**RE: Mesa Del Sol Self Storage
5500 Turing Dr. SE
Grading and Drainage Plan
Engineer's Stamp Date: 5/7/2025
Hydrology File: R16DA1004**

**Re: Mesa Del Sol Self Storage
 5500 Turing Dr. SE
 Grading and Drainage Plan
 Engineer's Stamp Date: 01/15/2025
 Hydrology File: R16DA1004**

Here are the responses to the comments provided on March 21, 2025 in regards to an **Updated Grading & Drainage prior to continuing onsite grading and foundation work.**

C-1.0

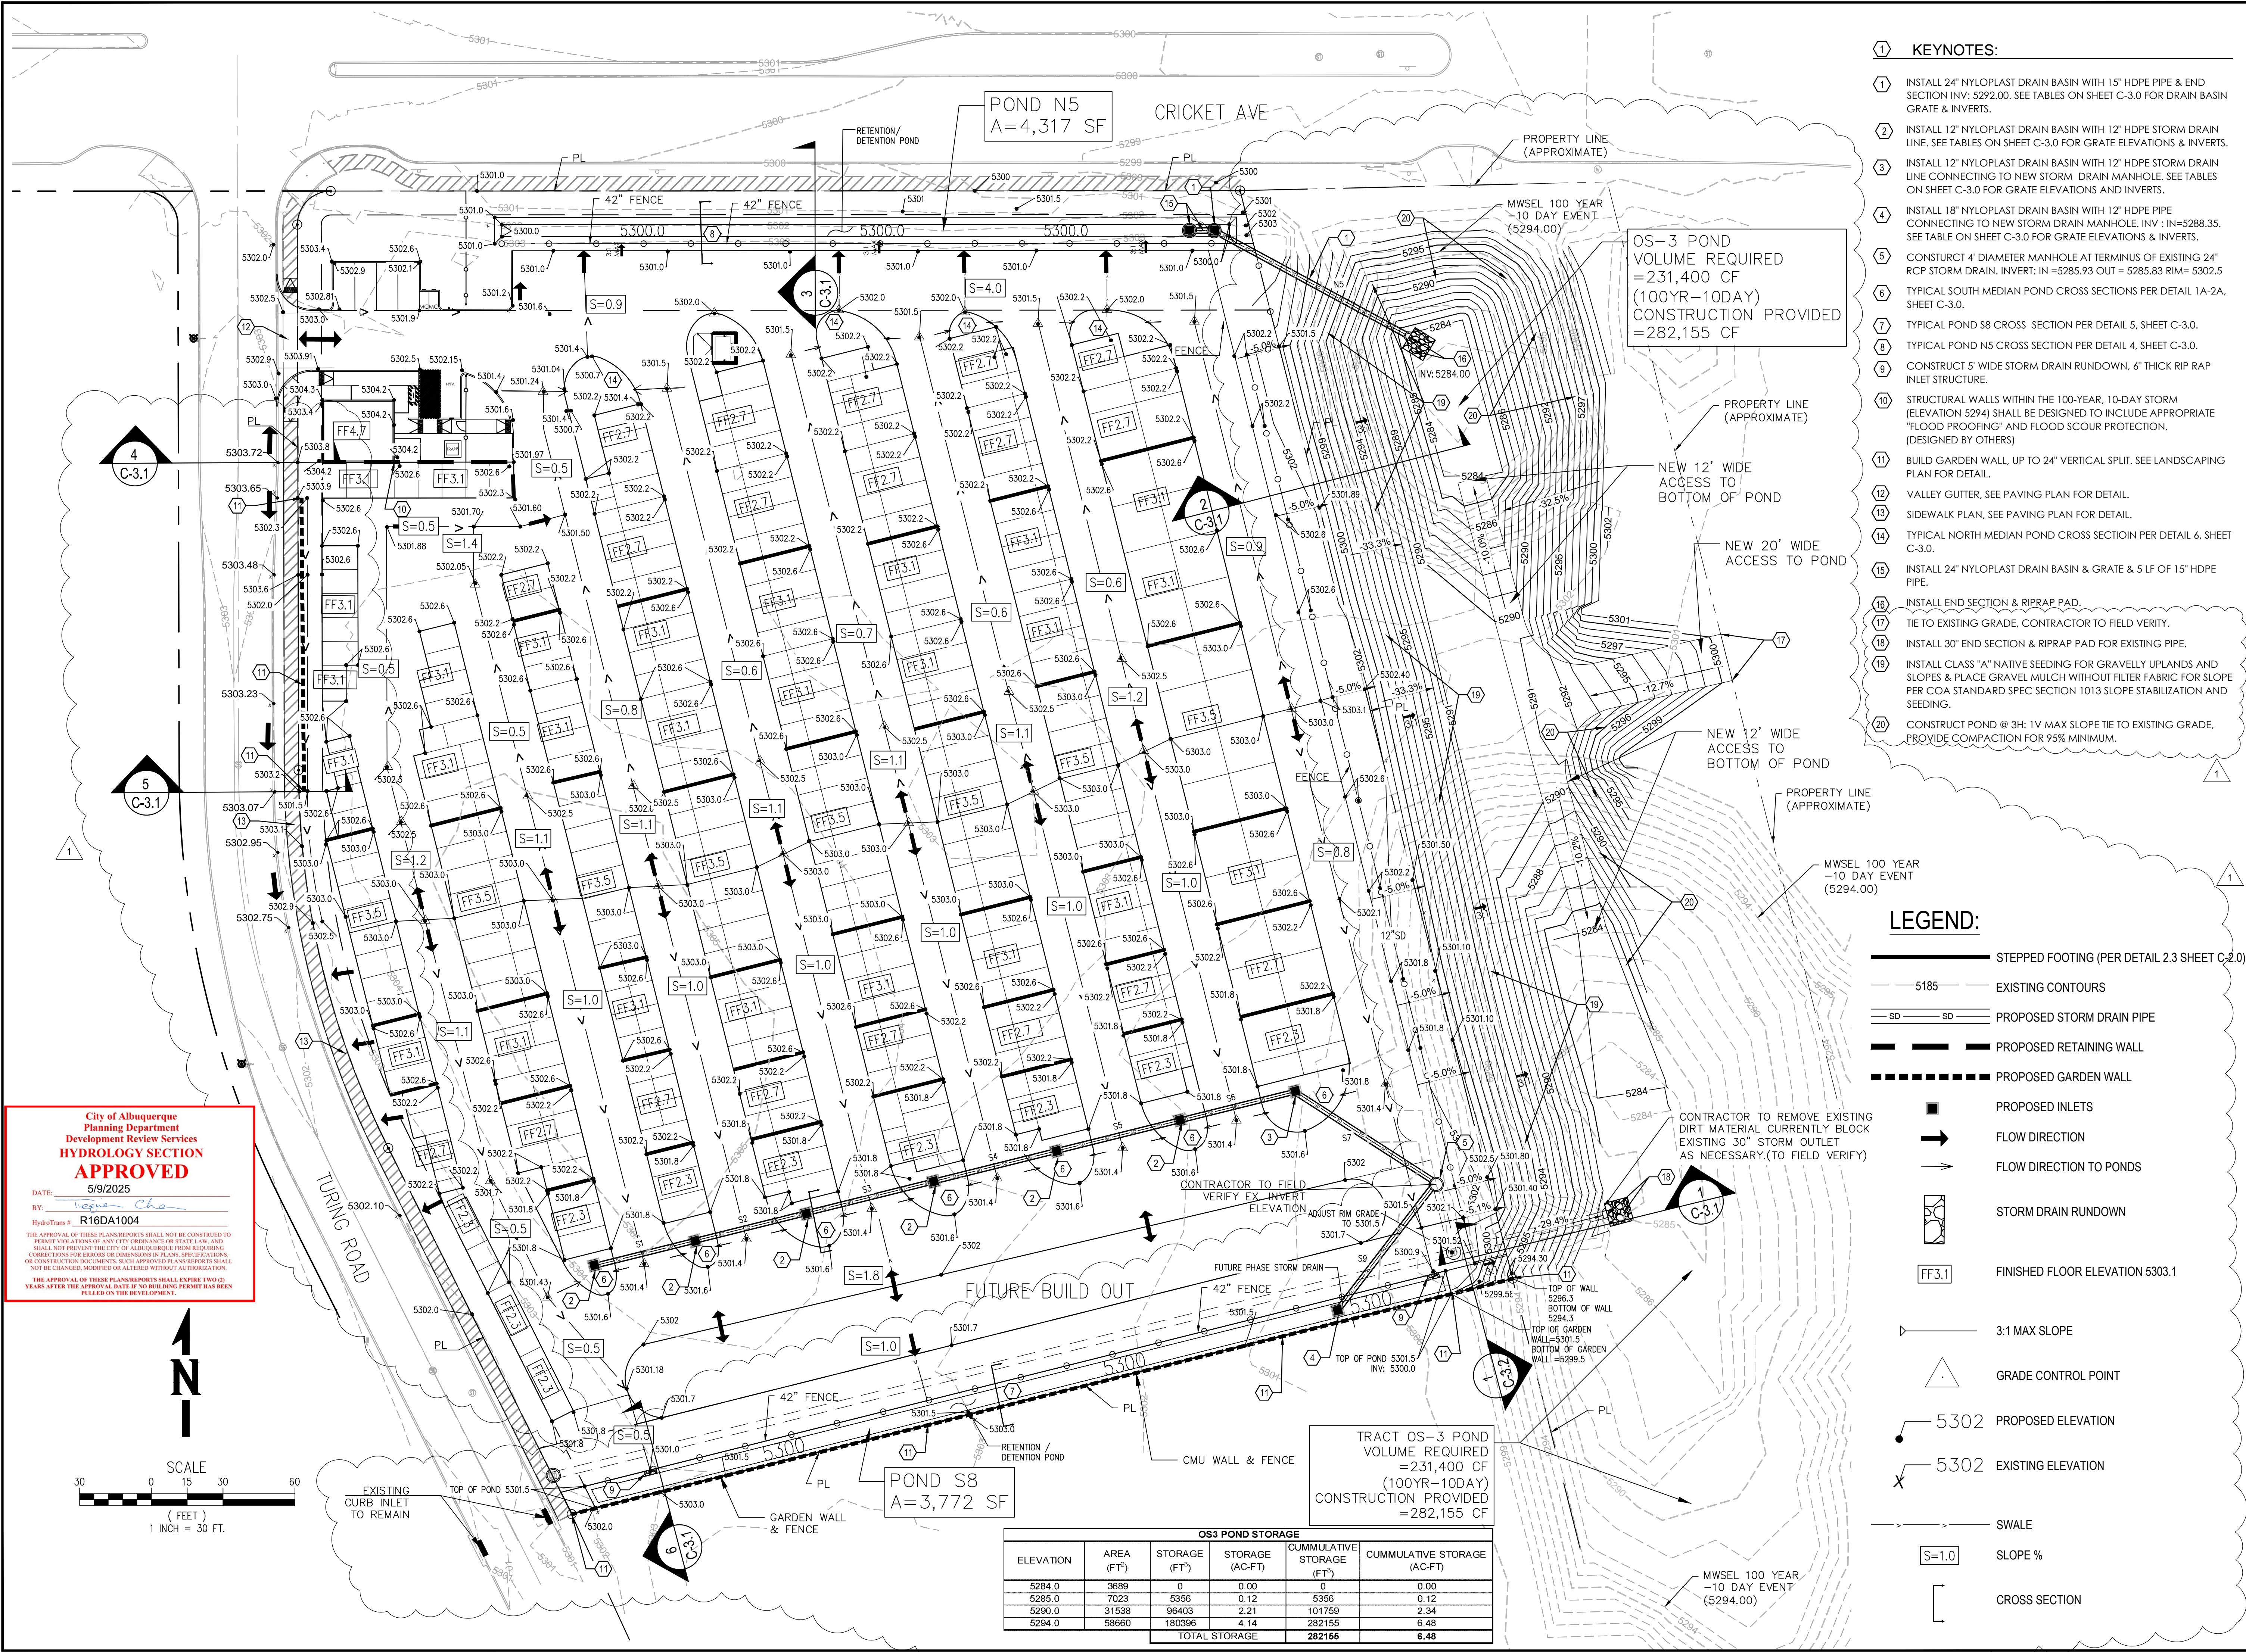
3. Most importantly, provide documentation allowing the use of and filling in the existing retention pond was promised months ago and has yet to be received by the CABQ, and include references to said documentation on the Updated Grading & Drainage Plan.
Response: There is no intend to use the existing retention pond material to use for filling of onsite construction, OS3 pond will be graded per revise Grading Plan C-1.0.

10. Show all portions of proposed retaining walls on the property of the project.
Concur. Please see revised grading plan for proposed garden wall locations, retaining wall eliminated per revised Grading Plan C-1.0.

11. The existing ponds should be completely developed for the 100-year 10-day storm and associated capacity, together with slope erosion protection and access barricades where needed.
Concur. See revised Grading Plan C-1.0 for existing pond improvement with pond capacity, erosion protection has been added to west side of pond per COA Section 1013 Slope Stabilization and Seeding on 3:1 slope.

12. Per follow up phone conversation on 4/29/2025, COA hydrology had requested to add access road to existing pond.
Concur. See revised Grading Plan C-1.0 for access road design into Tract OS-3 pond bottom.

SHEET NUMBER: **C-3.1**

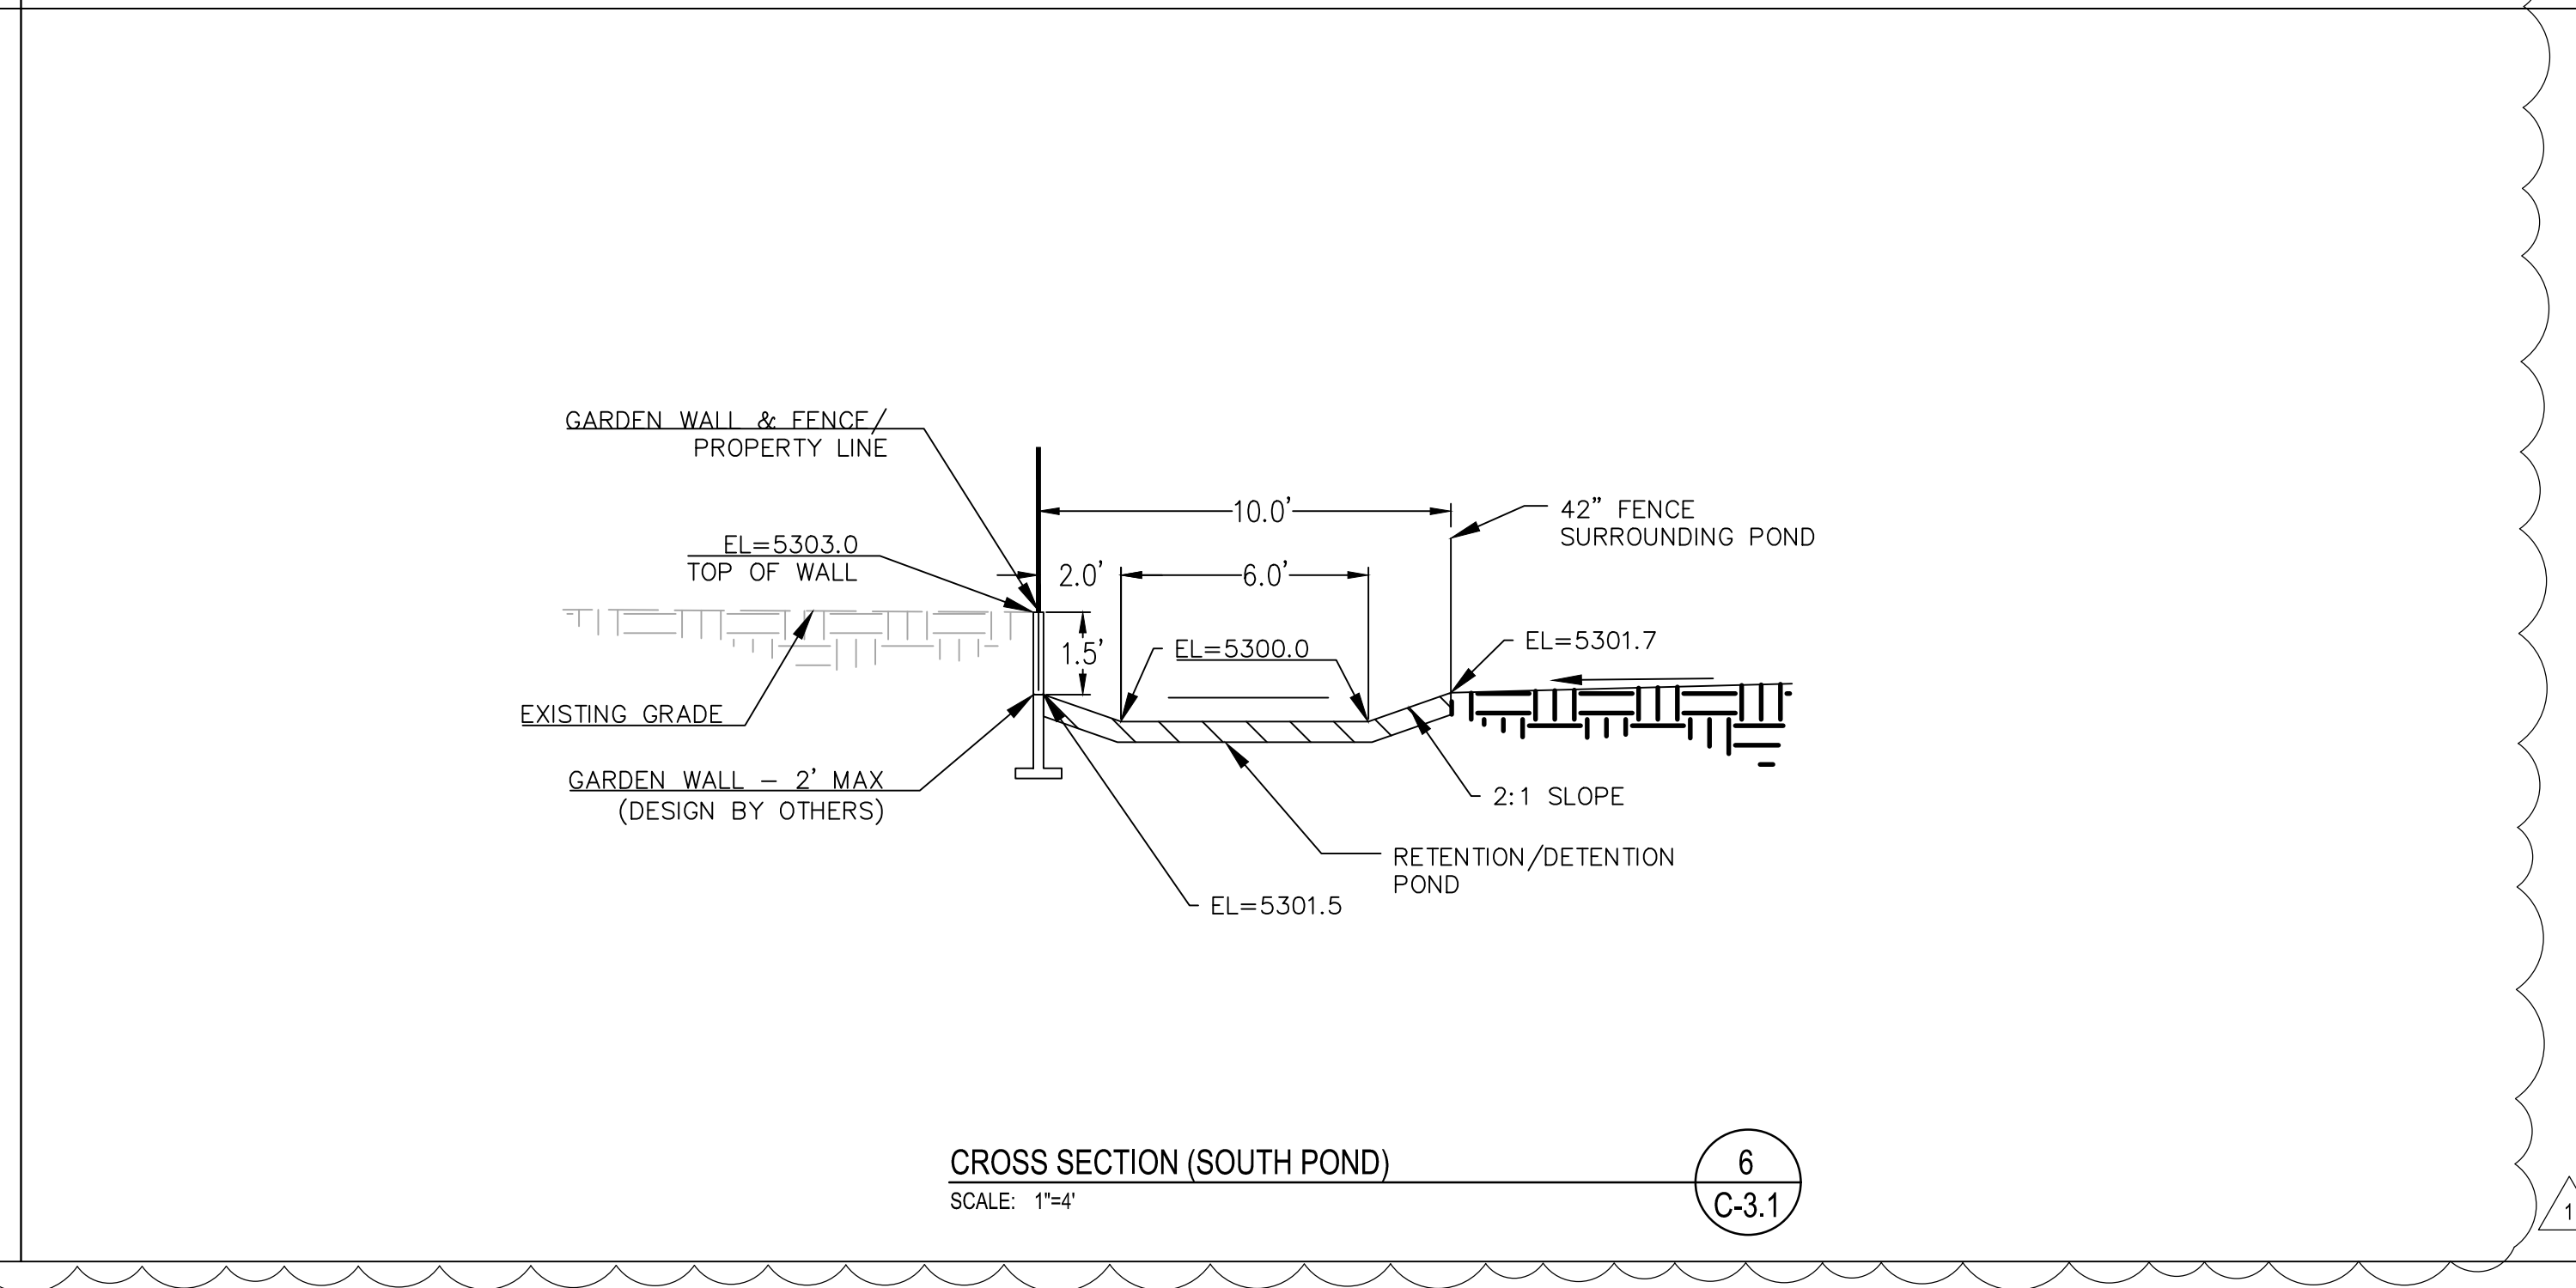
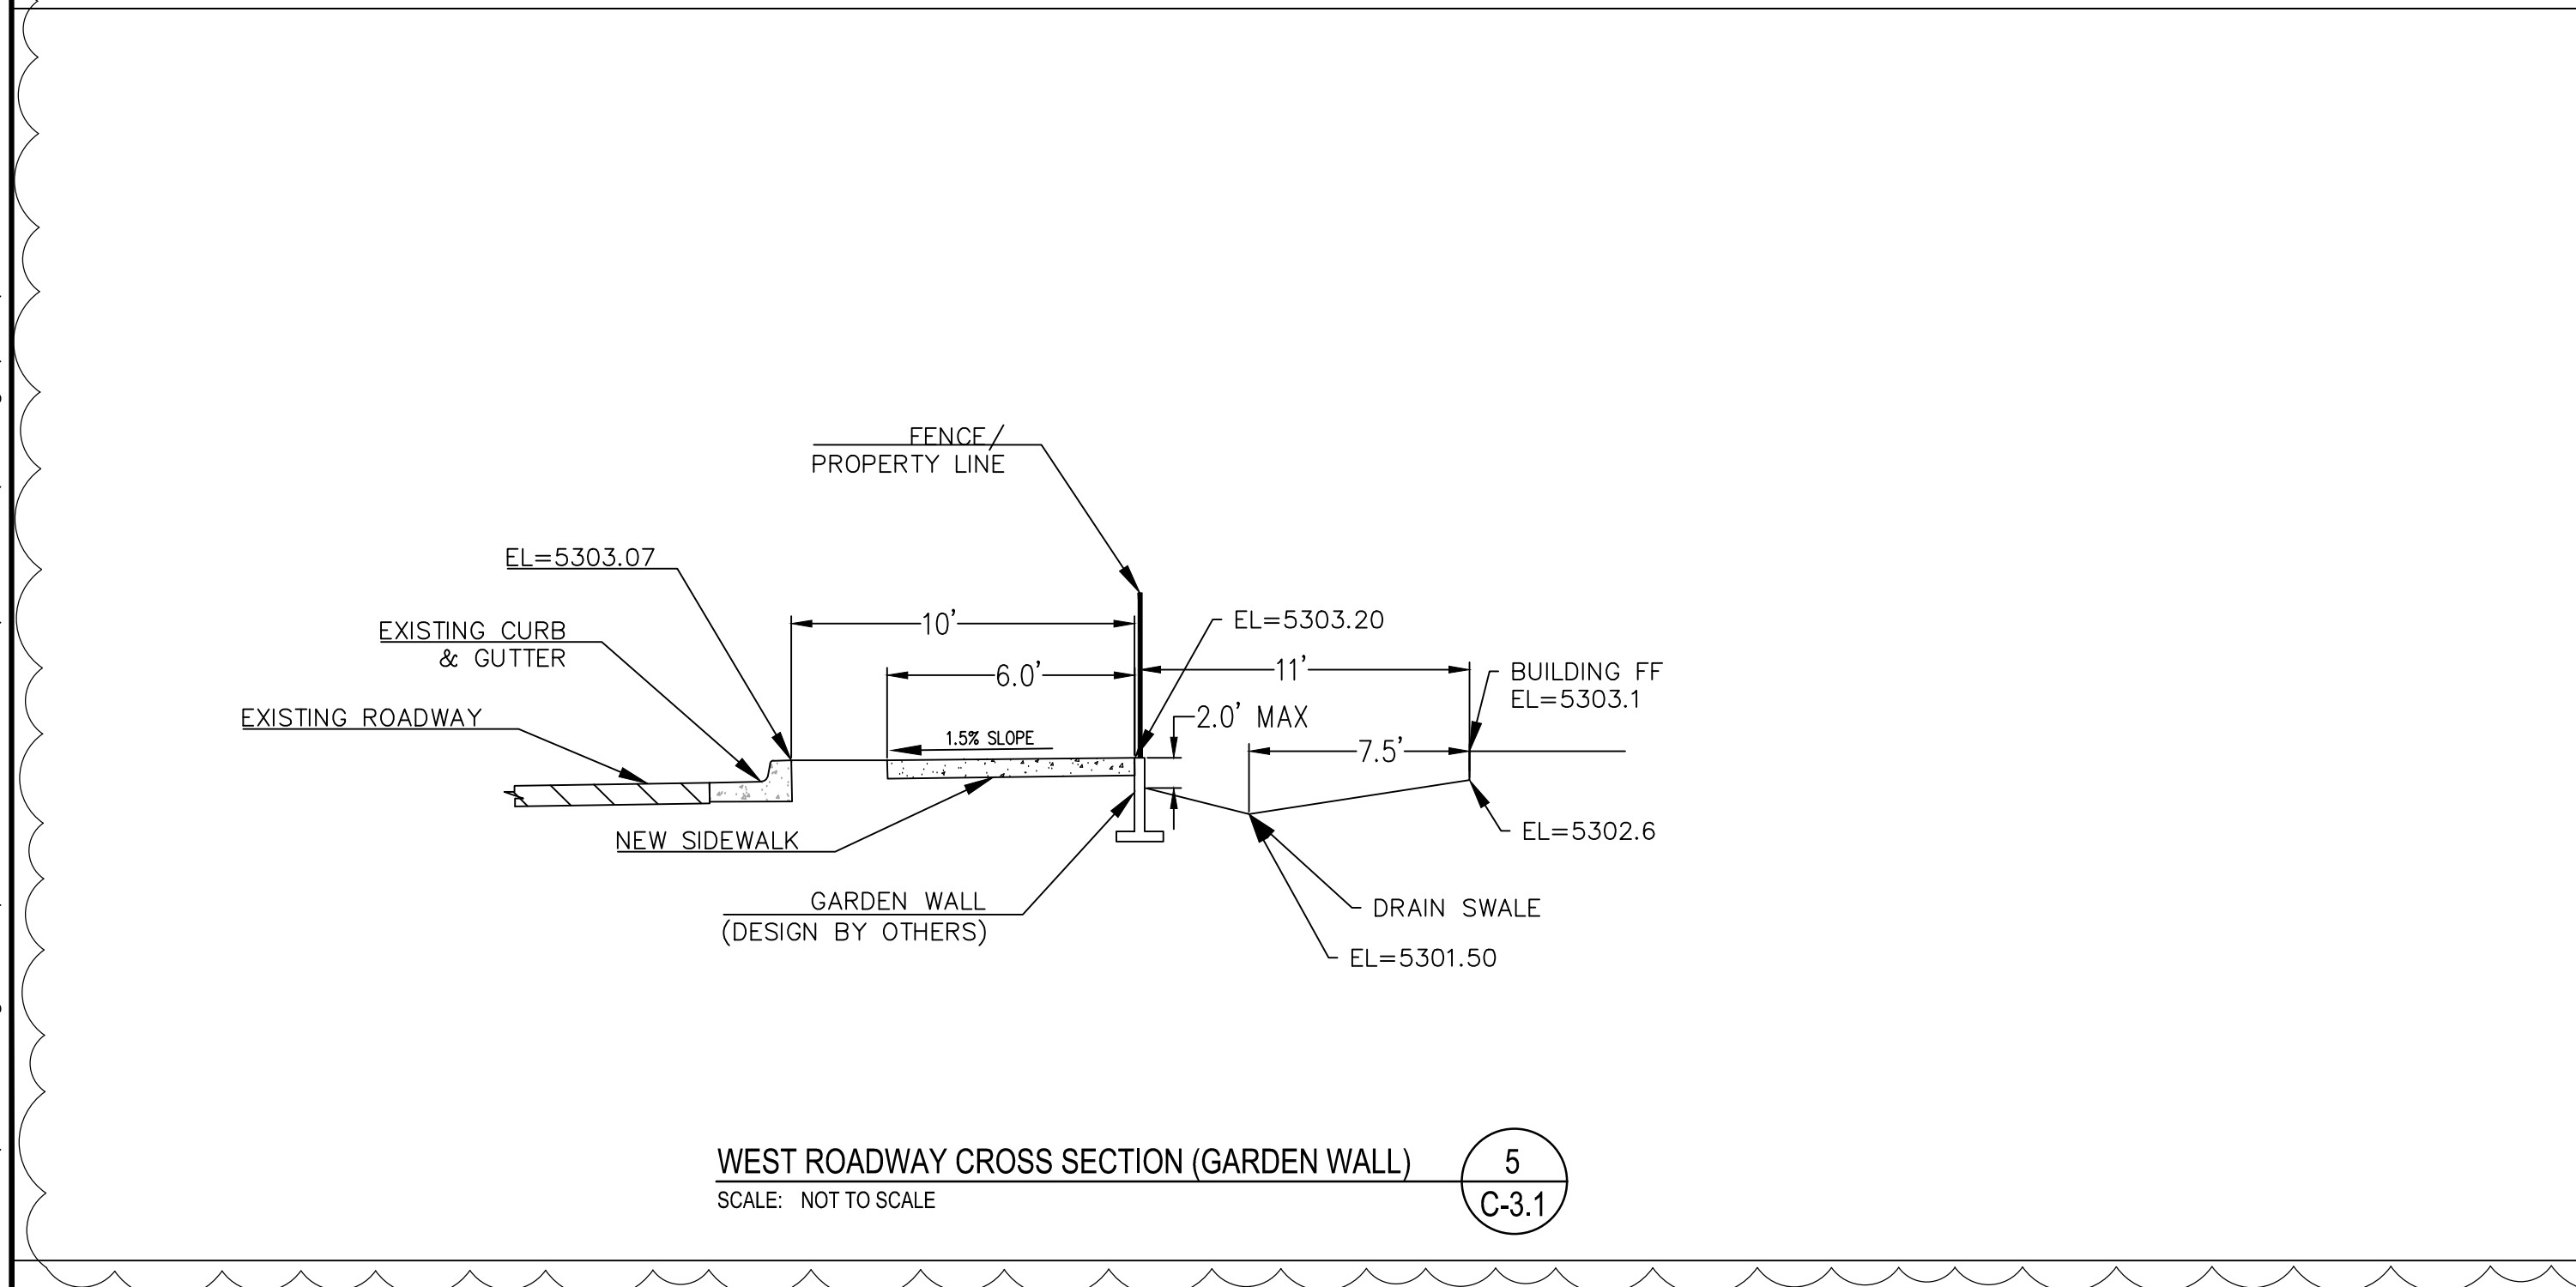
8. Due to the proposed retaining wall in Section 1 of C-3.1, provide an additional cross-section showing the existing storm drain manhole and pipe extension through the proposed retaining wall and into the retention basin at the southeast corner of the project.
Concur. Additional section has been added, see revised sheet C-3.1 & C-3.2. Retaining wall removed from revised design.
